# TECHNICAL MEMORANDUM

**Date:** November 9, 2020  
**AAA Ref:** FWPOB103.005  
**To:** James Weaver  
**Client Ref:**  
**Cc:** Brian Robinson  
**From:** Art Anderson  
**Subject:** Repair Concept for Fire Damage at Port Orchard Marina D Dock, Vicinity of D-27

# PORT OF BREMERTON PORT ORCHARD MARINA RECONSTRUCTION

### **Plan Set Review Comments**

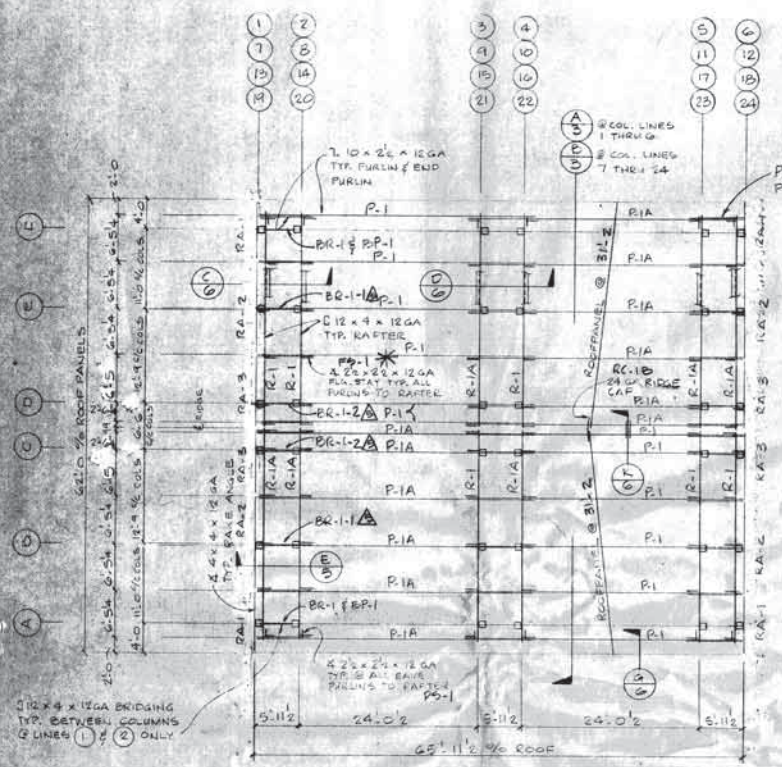
The following comments were noted on the last submittal with no response. These submittals are required.

- 3) Bumpers to protect columns and vessels from impacts were required by the Alternate B Bid Set Plans (see sheet B-5).
- 4) Roof panel cutouts details sheet 1 of 1 show edge purlin offset at 2'6" Section details throughout remainder of plan set show 2'-0", for example G/4 on C-Dock.

Dock C sheet 2 of 6 - Section C/2 - This detail shows a gap between the rub strip and finger waler. What is gap? - Comment typical on all roof cover plans.

Dock C sheet 2 of 6 - Section D/2 - The base plate needs to be sized. There appears to be a conflict between finger thru rods and column base plate bolts. Comment typical on all roof cover plans.
